AGENDA
CHARTER TOWNSHIP OF MERIDIAN
PLANNING COMMISSION – REGULAR MEETING
July 8, 2019 7PM

**CHARTER TOWNSHIP OF MERIDIAN
PLANNING COMMISSION
REGULAR MEETING MINUTES**

To: Planning Commission

PROJECT	DBH
CHECKED	DBH
DRAWN	HTK
DATE	18-0066
SCALE	11/12/18
SHEET NO.	40
TOTAL SHEETS	C4.0

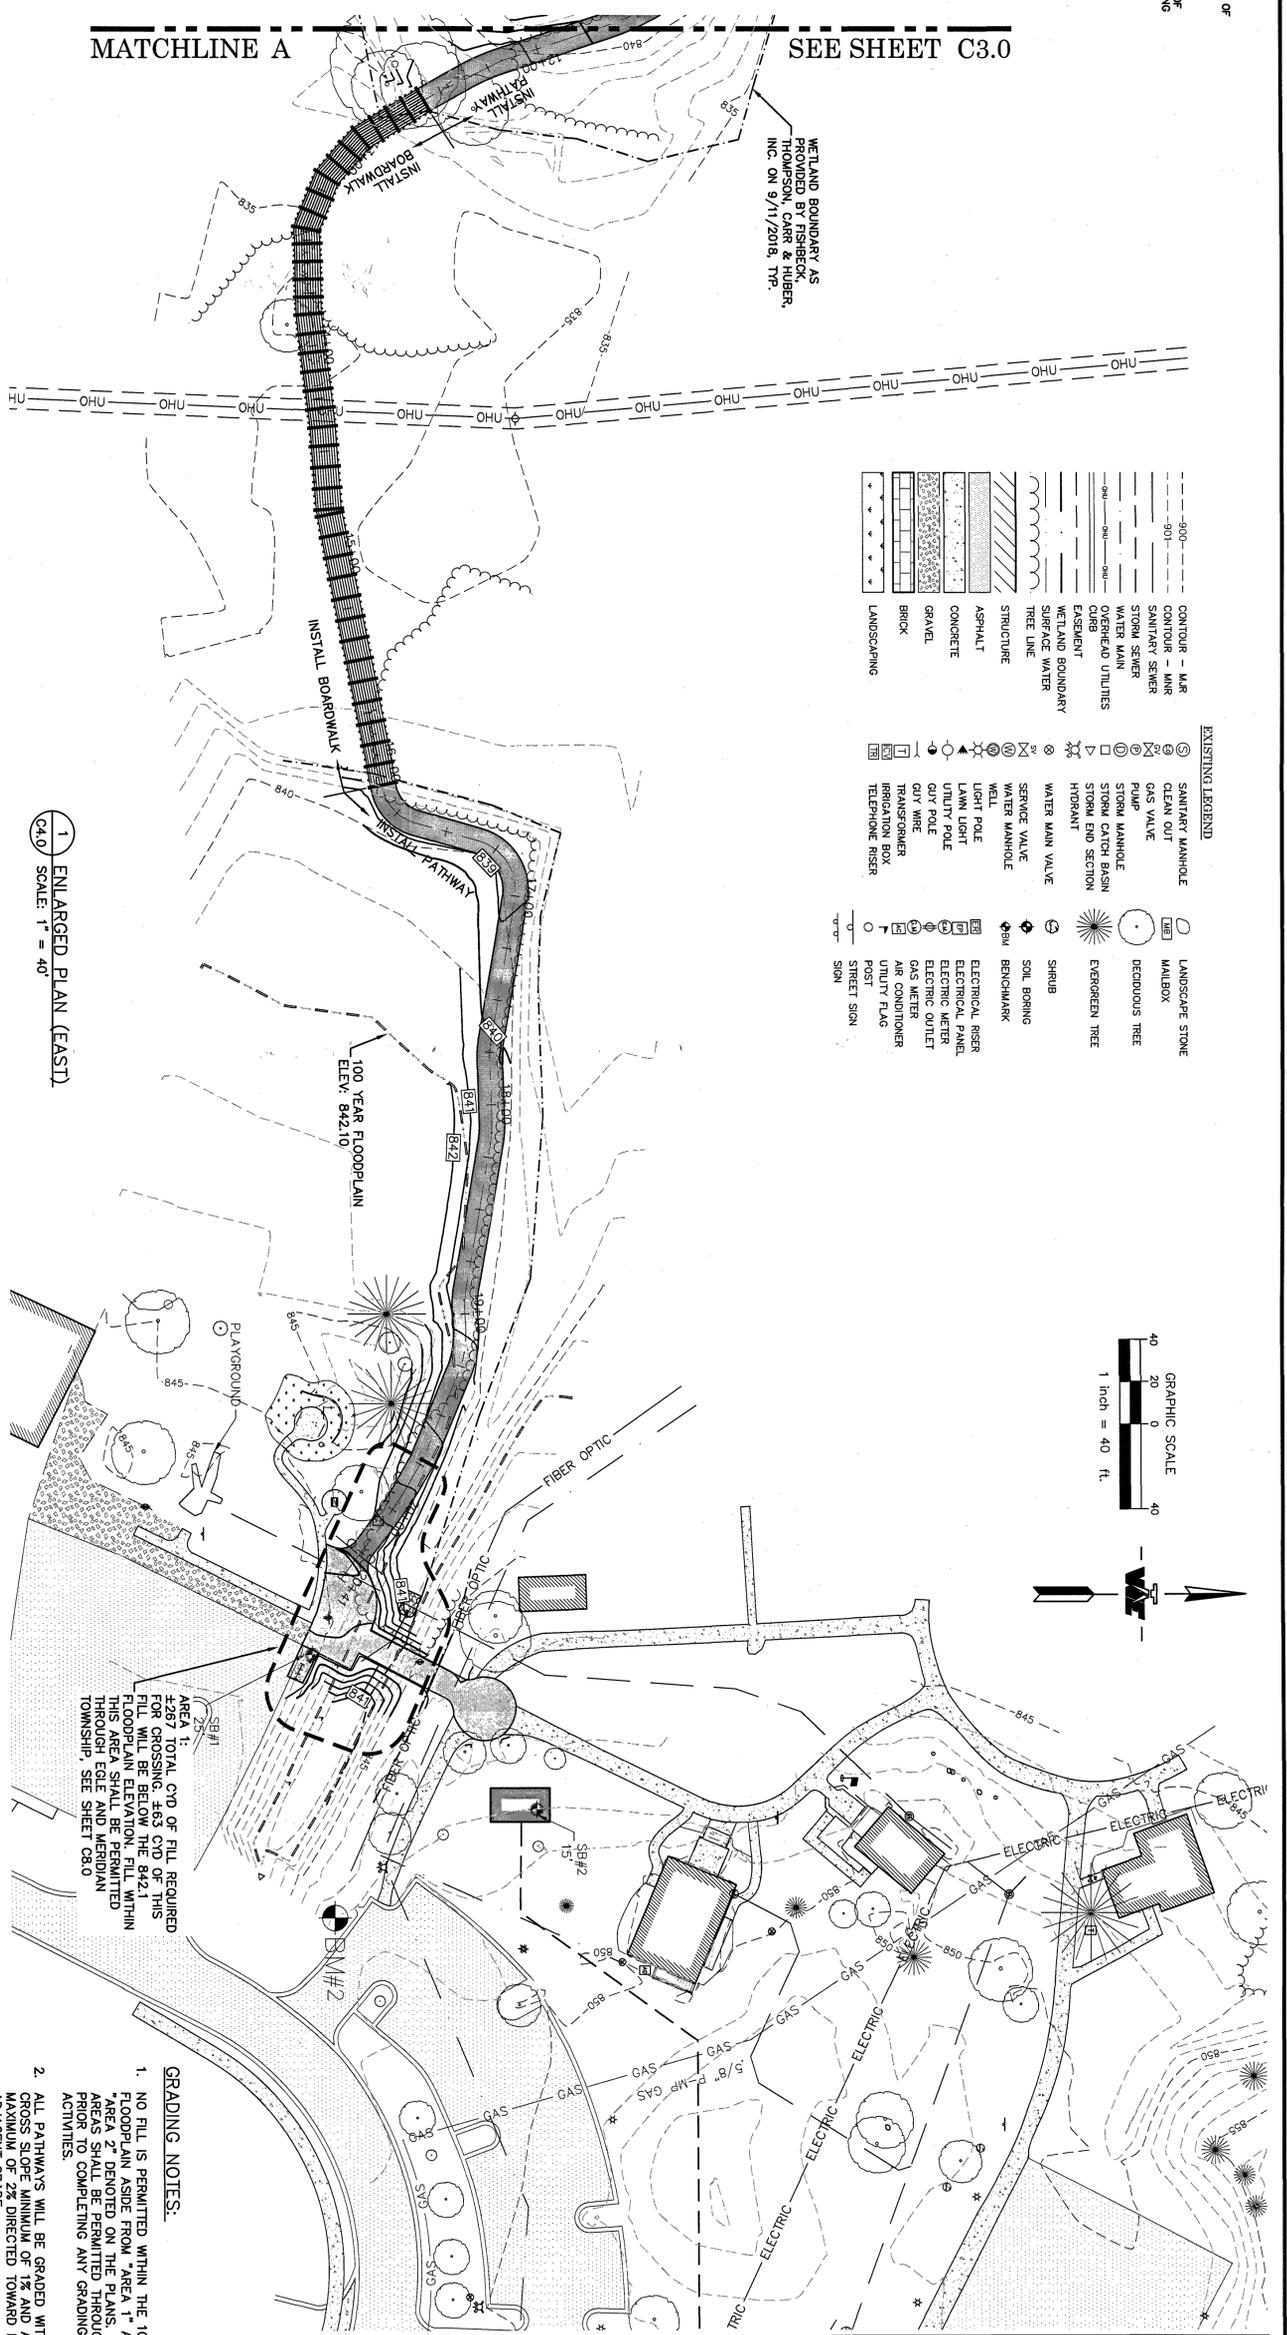
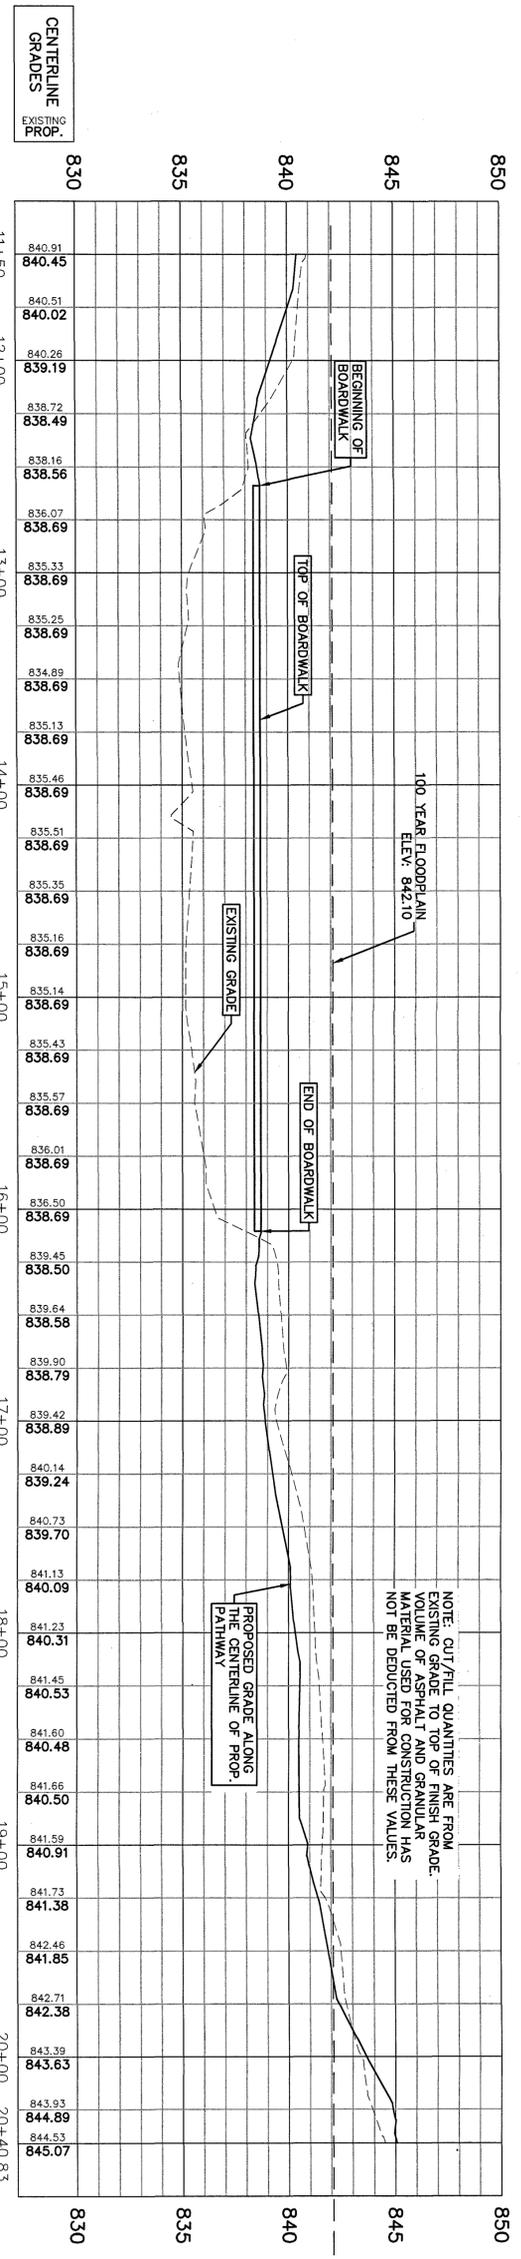
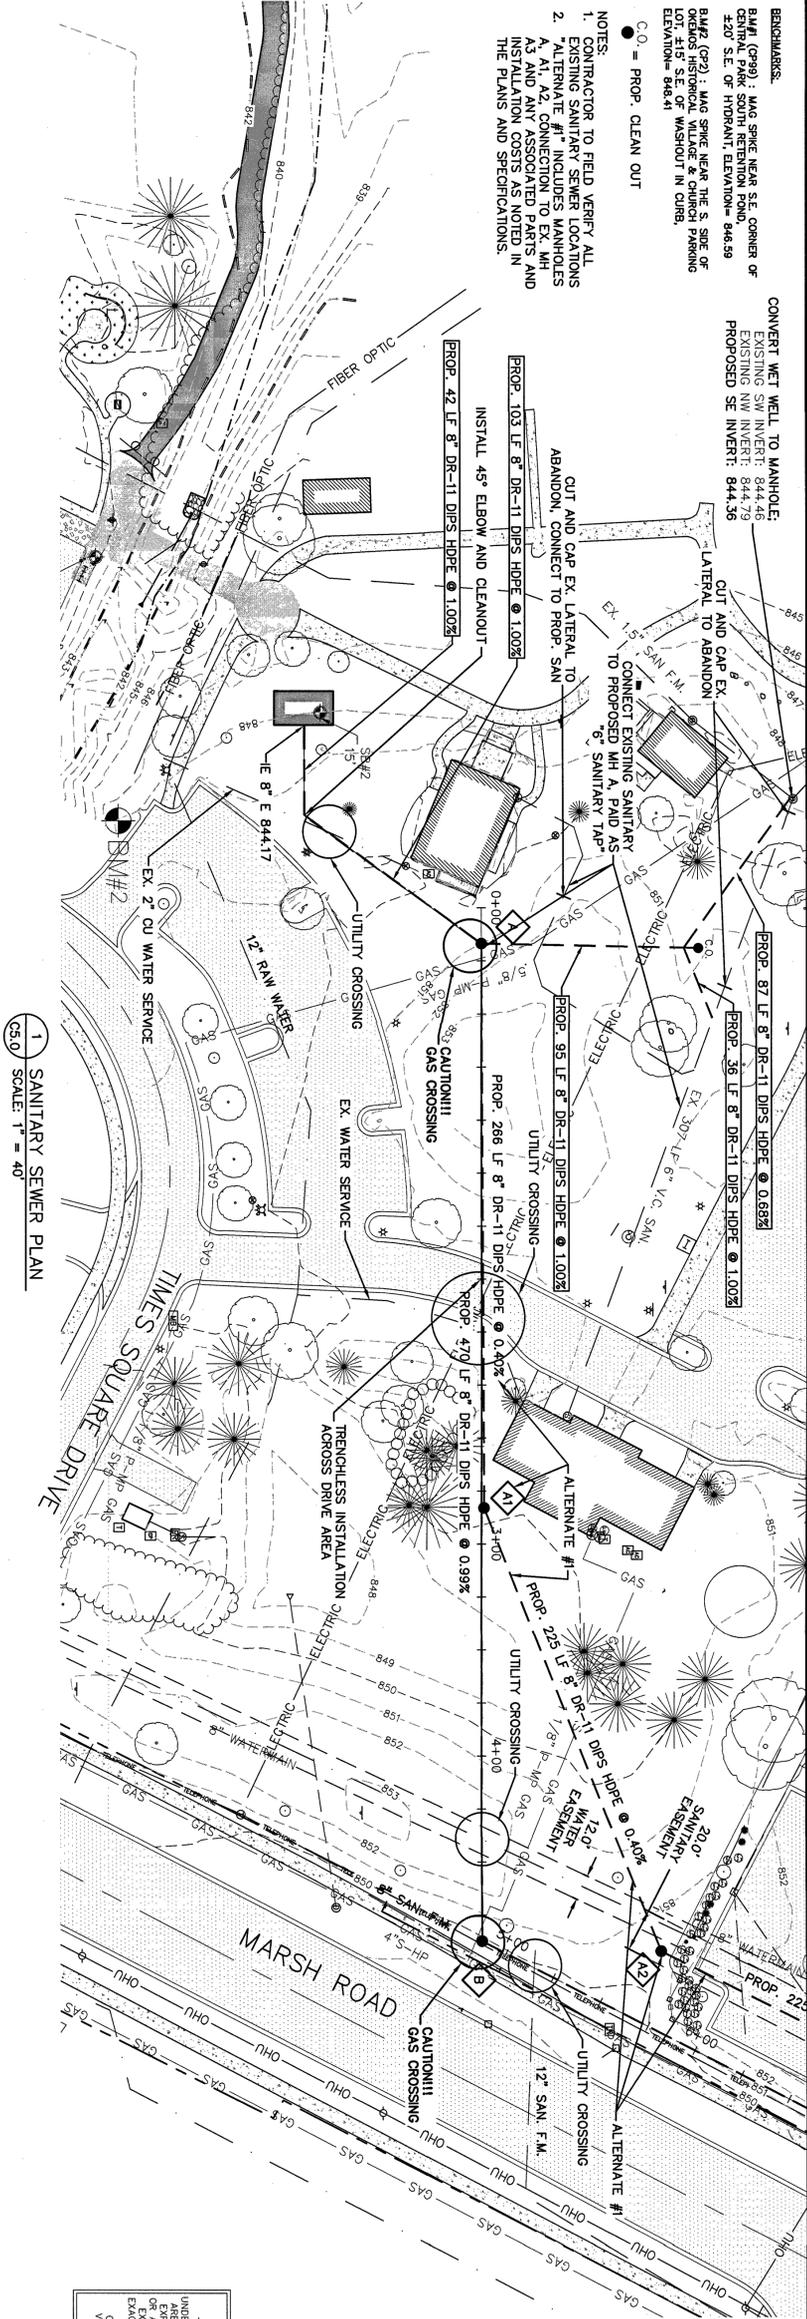
Clarify plan table on sheet C4.0

Table has been removed from plans as it related to cut and fill for the entire project and not just work within floodplain/wetland areas. Please see "Correction request statement" and notes/cross-sections shown on sheets C7.0 & C8.0 for additional cut/fill information.
